Site: Padnell Grange, Cowplain, Hampshire, PO8 8ED

Further to your recent application for a level 2 enquiry regarding the above development site.

**Study into the Options for Foul Drainage Provision along Padnell Road and
Surface Water Drainage Provision along Padnell Road and Cherry Tree
Avenue, Budds Farm.**

STUDY INTO THE OPTIONS FOR
FOUL DRAINAGE PROVISION AT
PADNELL GRANGE
COWPLAIN
HAMPSHIRE
PO8 8ED

Figure 2 - Proposed Improvements – Foul system

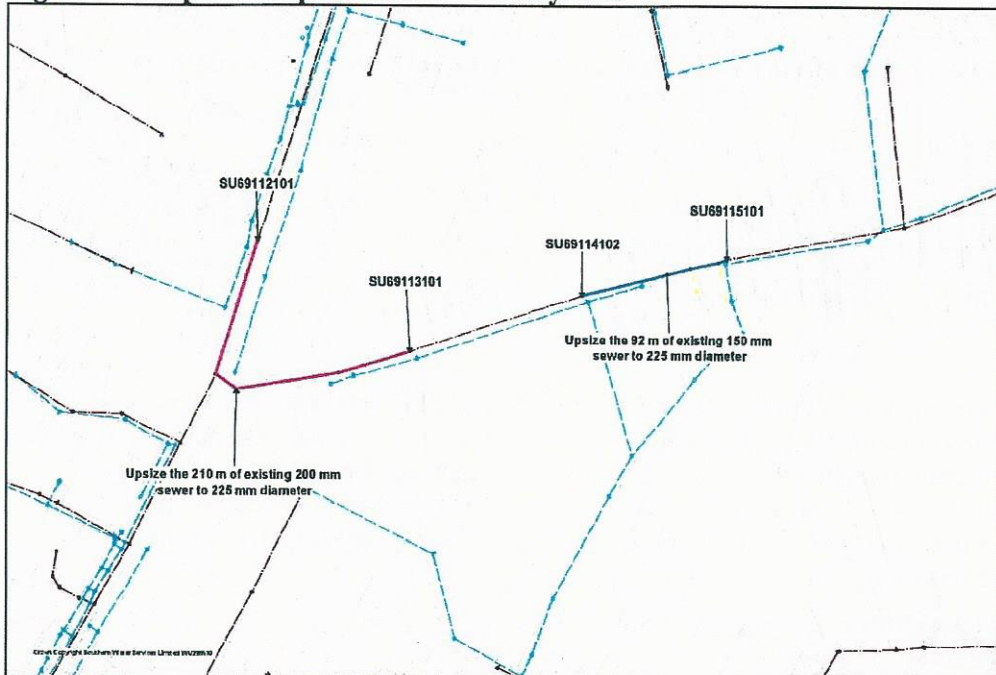
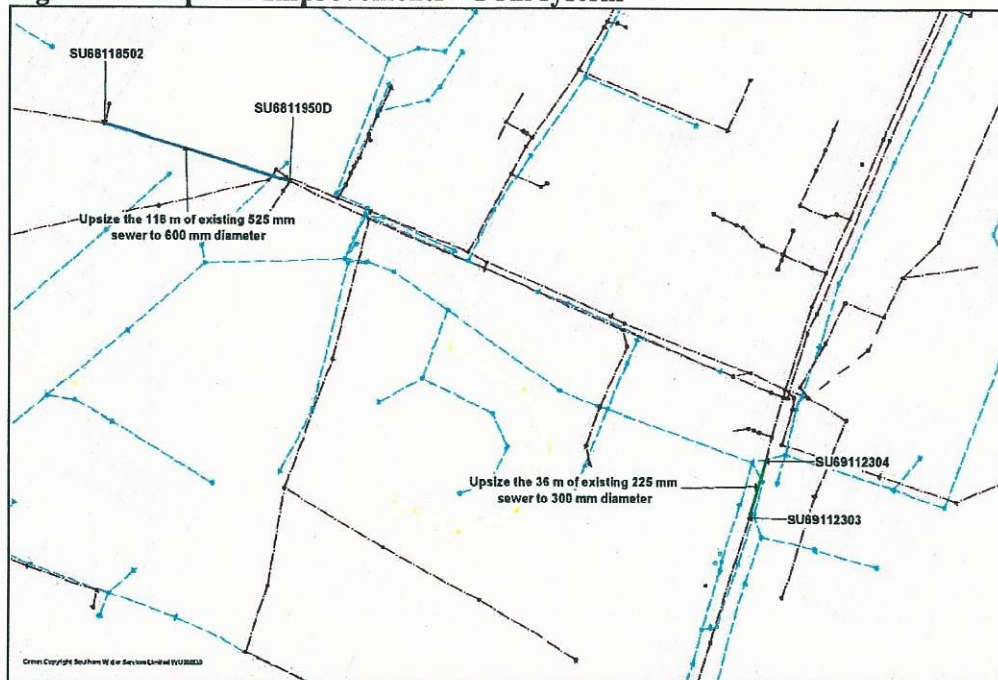
There is a discrepancy between the Asset data and the modelled database. The sewer diameter between manhole's SU69112303 – SU69112304 is referred as 200 mm in Asset data whereas modelled as 225 mm in modelled database. The data within the hydraulic model has been used for the purpose of this investigation. It is recommended that the sewer layout is confirmed prior to further development of the recommended scheme.

There is currently inadequate capacity within the local foul sewerage network to accommodate a flow of 3.7 l/s at manhole reference SU69117201. The proposed development would increase flows to the local network and as a result existing properties and land may be subject to a greater risk of flooding. Additional off-site sewers or improvements to existing sewers will be required to provide sufficient capacity to service the proposed development as indicated in Figure 2, & 3 and Table 2.

U/S Manhole	D/S Manhole	Sewer Diameter (mm)		Avg. Depth (m)	Length (m)
		Existing	Proposed		
SU69115101	SU69114102	150	225	2.1	92
SU69113101	SU69112101	200	225	4	210
SU69112303	SU69112304	225	300	2.7	36
SU6811950D	SU68118502	525	600	3.9	118

Figure 4 - Proposed Improvements – Surface water system

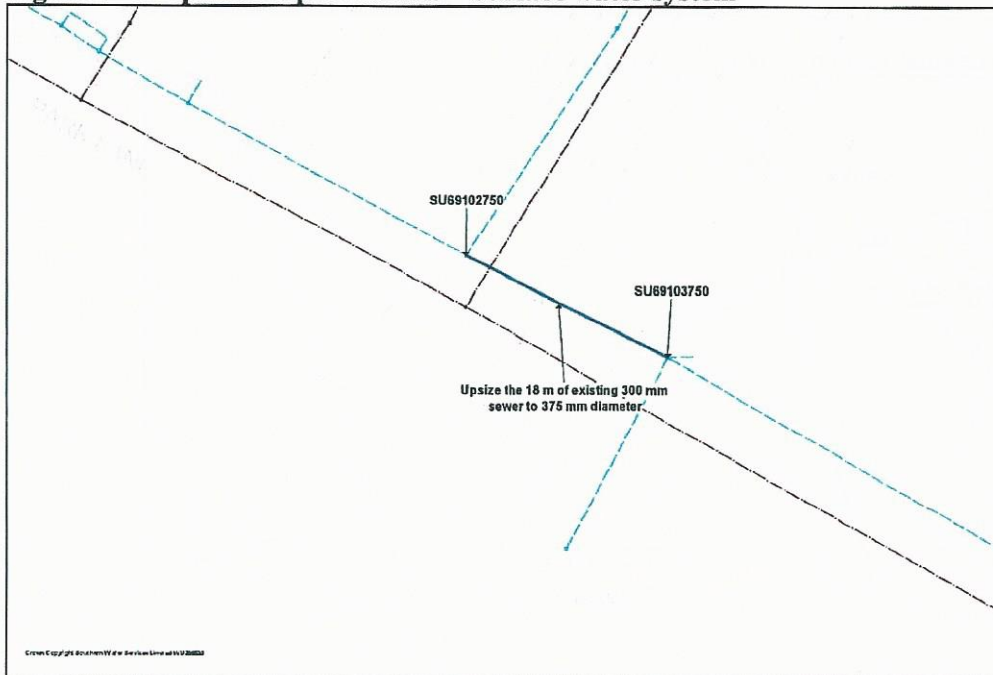
There is currently inadequate capacity in the local surface water network to accommodate a surface water flow of 3.5 l/s at manhole reference SU69117251 or manhole reference SU69118250. Additional off-site sewers or improvements to existing sewers will be required to provide sufficient capacity to service the proposed development as indicated in Option 1 (Figure 4 and Table 3) and Option 2 (Figure 5 & 6 and Table 4).

U/S Manhole	D/S Manhole	Sewer Diameter (mm)		Avg. Depth (m)	Length (m)
		Existing	Proposed		
SU69102750	SU69103750	300	375	1.1	18

Figure 2- Proposed Improvements – Foul system

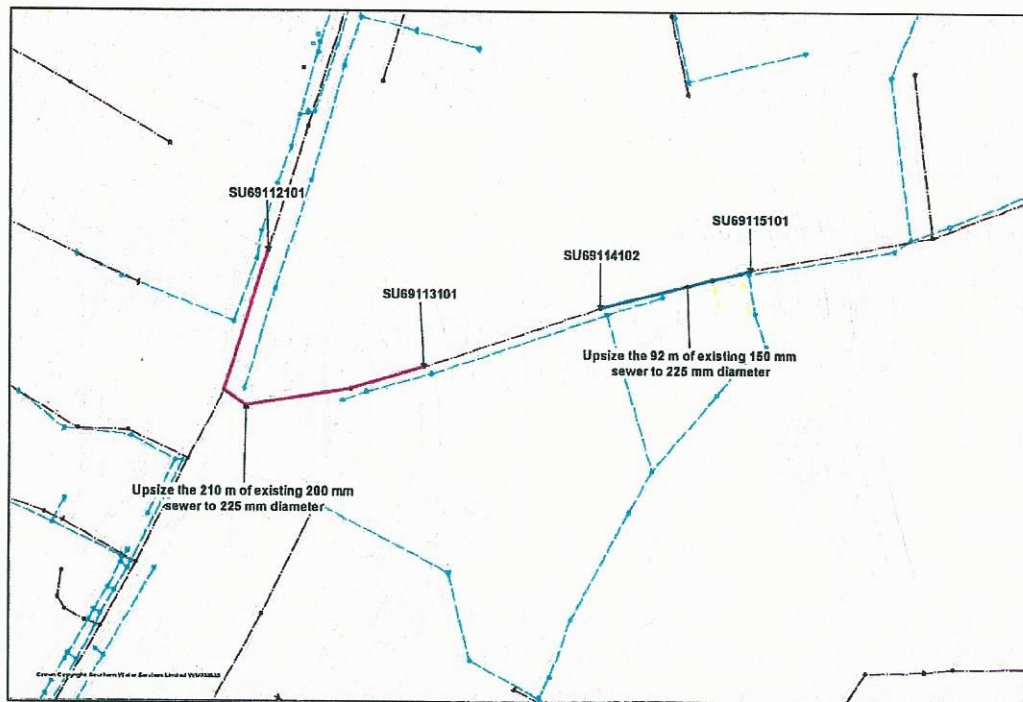
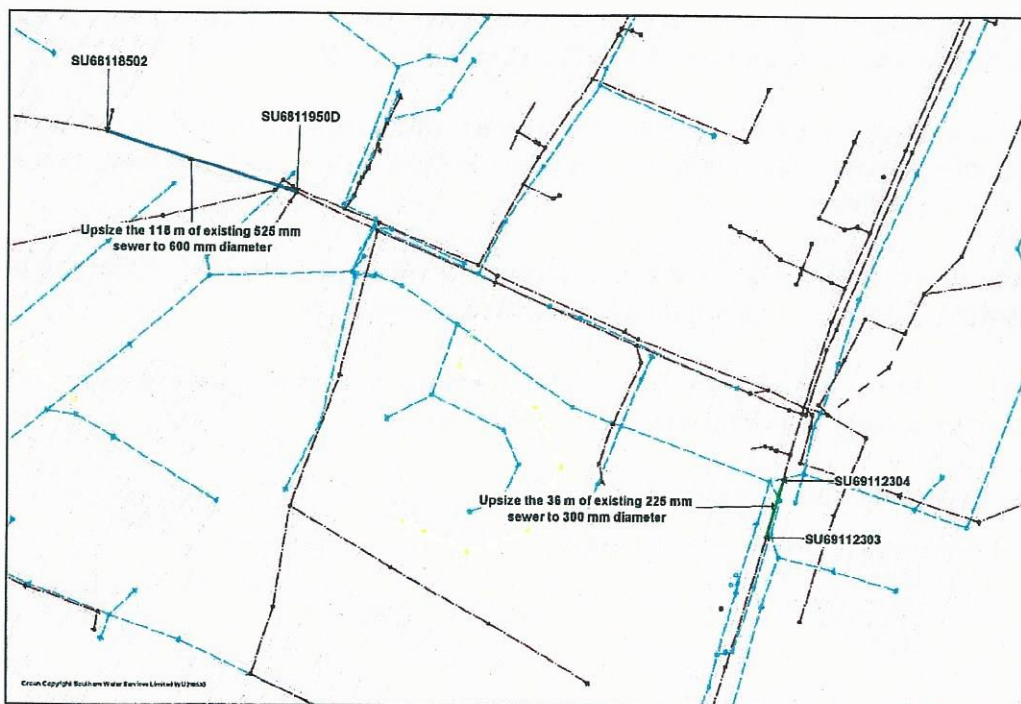
There is currently inadequate capacity within the local foul sewerage network to accommodate a flow of 3.7 l/s at manhole reference SU69117201. The proposed development would increase flows to the local network and as a result existing properties and land may be subject to a greater risk of flooding.

Additional off-site sewers or improvements to existing sewers will be required to provide sufficient capacity to service the proposed development as indicated in Figure 2 & 3 and Table 1.

There is a discrepancy between the Asset data and the modelled database. The sewer diameter between manhole's SU69112303 – SU69112304 is referred as 200 mm in Asset data whereas modelled as 225 mm in modelled database. The data within the hydraulic model has been used for the purpose of this investigation. It is recommended that the sewer layout is confirmed prior to further development of the recommended scheme.

U/S Manhole	D/S Manhole	Sewer Diameter (mm)		Avg. Depth (m)	Length (m)
		Existing	Proposed		
SU69115101	SU69114102	150	225	2.1	92
SU69113101	SU69112101	200	225	4	210
SU69112303	SU69112304	225	300	2.7	36
SU6811950D	SU68118502	525	600	3.9	118

Figure 4- Proposed Improvements – Surface water system

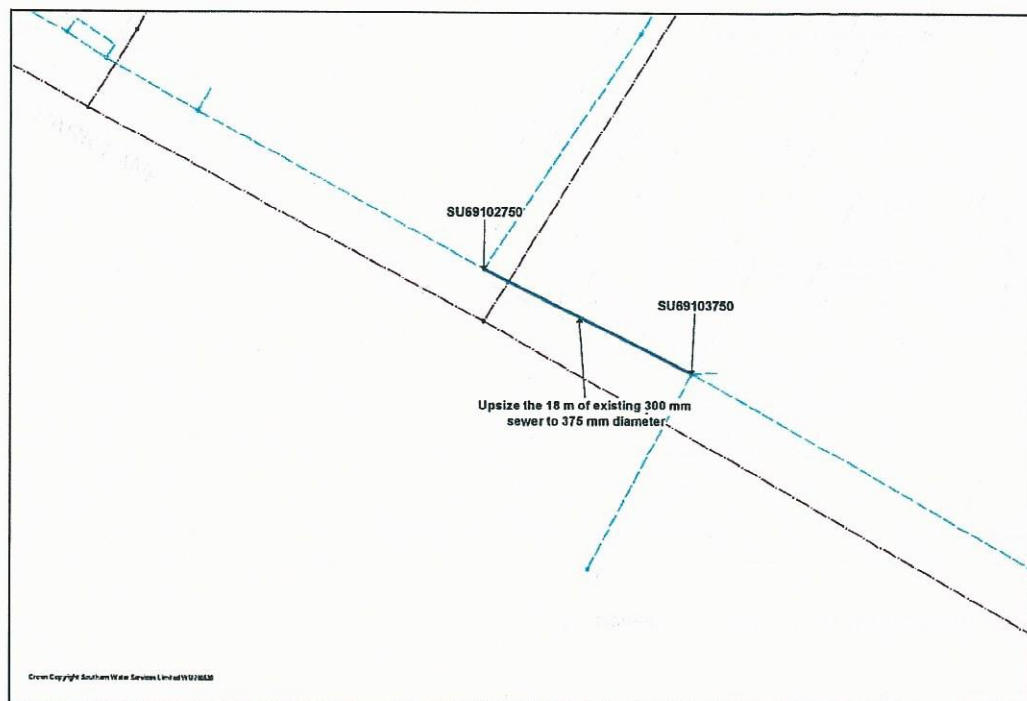
There is currently inadequate capacity in the local surface water network to accommodate a surface water flow of 3.5 l/s at of manhole reference SU69117251 or SU69118250.

Additional off-site sewers or improvements to existing sewers will be required to provide sufficient capacity to service the proposed development as indicated in Option 1 (Figure 4 and Table 2) and Option 2 (Figure 5 - 6 and Table 3).

U/S Manhole	D/S Manhole	Sewer Diameter (mm)		Avg. Depth (m)	Length (m)
		Existing	Proposed		
SU69102750	SU69103750	300	375	1.1	18
